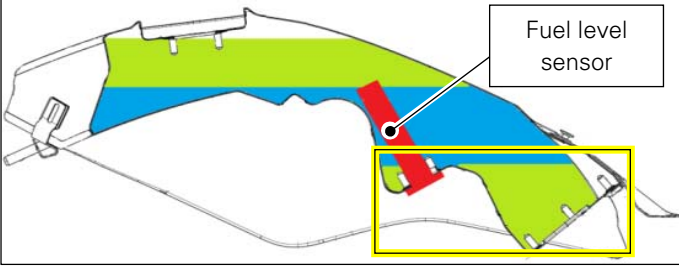
no.	Symptom	Subject	Photo	Trouble Code (Diagnostic Trouble Code)	Part no.	Notes/Indications/Corrective action
1	Possible display of dashes on the odometer value indication	Instrument panel		There is no error in the control unit	-	<p>Mismatch between the odometer value displayed on instrument panel and the one stored in the BBS.</p> <p>It is necessary to use the DDS to update the software version of the instrument panel with the Version 11.</p> <p>To eliminate the odometer value mismatch, it is necessary to fill in a Youtech Request asking for the DDS password.</p>
2	Possible vibration of the vertical cylinder exhaust manifold cover	Vertical cylinder exhaust manifold cover Part no. 46110401A		<p>Vibration due to loosening of one of the two retaining screws; check the tightening of the two screws. DMH has added a check based on the VIN ZDMGA00AAGB001001.</p> <p>As a precaution, you can check the tightening of these two screws during the pre-delivery operations. Remove the rider seat and fuel tank rear retaining screw; lift up the fuel tank from the rear side by 9 cm while keeping it in position with a block. Use a 4-mm Allen wrench to tighten the two screws to 6 Nm.</p>

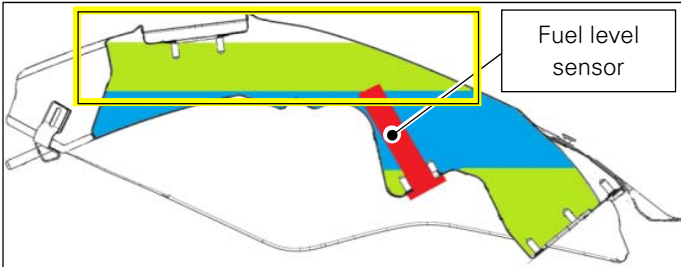
no.	Symptom	Subject	Photo	Trouble Code (Diagnostic Trouble Code)	Part no.	Notes/Indications/Corrective action
3	Possible turning off of some pixels on the instrument panel	Instrument panel		<p>It is not necessary to replace the instrument panel.</p> <p>There is no error in the control unit</p>	-	<p>We have identified a possible inaccuracy in the instrument panel software, only from serial number 000400 to 000899.</p> <p>It is necessary to update the instrument panel software version.</p> <p>To update the instrument panel software version you will be reimbursed for a labour time of 18 minutes (3WU); for the reimbursement request wait the Workshop Campaign to be issued soon.</p>
4	The sticker is not perfectly applied on the swinging arm	<p>The sticker has the following text:</p> <p>“WARNING: The counter-weights for the dynamic balancing of the rear wheel must be positioned as shown in the figure.”</p> <p>To balance the rear wheel, place the counter-weights in the positions indicated in the figures, at the distance from the rim outer edge specified in the relevant drawing.</p>		<p>The sticker position has been changed.</p> <p>It is therefore possible to remove it from the previous position and apply it on the rear mudguard in the area indicated in the figure to the side.</p> <p>In case of sticker replacement, pay attention to the values since they are different for the STD and the S. versions.</p>	<div style="display: flex; justify-content: space-around; margin-top: 10px;"> <div style="text-align: center;"> <p>STD version – part no. 43314291A</p> </div> <div style="text-align: center;"> <p>S version – part no. 43314301A</p> </div> </div>

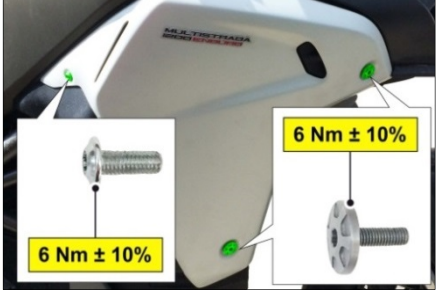
no.	Symptom	Subject	Photo	Trouble Code (Diagnostic Trouble Code)	Part no.	Notes/Indications/Corrective action
10	<p>S version ONLY</p> <p>Possible vibration of aluminium rear-view mirrors</p>	<p>Aluminium rear-view mirrors</p>		<p>Check the correct tightening of the rear screws Part no. 77750183C fastening the rear-view mirror support arm.</p> <p>To restore the correct tightening of the screws Part no. 77750183C, apply Loctite 243 along the screw threading and tighten the screws M4x8 to a torque of 2.5 Nm.</p> <p>We would like to inform you that the replacement of the rear-view mirrors is not required.</p>		
11	<p>Possible rider seat plate detachment</p>	<p>Rider seat plate</p>				<p><u>Should the rider seat plate detach, do NOT replace the seat.</u></p> <p>To secure the plate again it is necessary to refit the clips Part. no. 85044251A available at our spare part warehouse.</p> <p>To fit the clips Part no. 85044251A follow the procedure indicated below:</p> <ol style="list-style-type: none"> 1) Working on the seat lower side, make an opening on the thermal protection in correspondence of the plate fastening area, paying attention not to damage the elastic band; 2) Position the plate by inserting the 2 pins in the relevant holes on the seat; 3) Fit the 2 clips Part. no. 85044251A on the plate pins using a box wrench to make the operation easier.

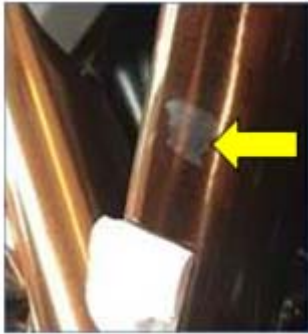
no.	Symptom	Subject	Photo	Trouble Code (Diagnostic Trouble Code)	Part no.	Notes/Indications/Corrective action
1	The supplied kit contains 2 unnecessary M10x70 screws	Supplied kit		-	-	<p>The first batch of kits supplied with the bikes contains 2 M10x70 screws that cannot be used for the bike pre-delivery and are not part of the bike parts list.</p> <p>It is necessary to remove these 2 M10x70 screws as they have no function.</p>
2	The Touratech side panniers are difficult to be inserted in the relevant subframes during the assembly and removal procedures	Touratech side panniers		-		<p>Should you have this problem, use pliers to deform the side pannier upper closing bracket by a few degrees upwards to avoid any interference of the bracket with the subframe upper pipe.</p>  <p>Upon bike delivery to the Customer, always show the correct engagement and disengagement procedure of the side panniers on the bike.</p>
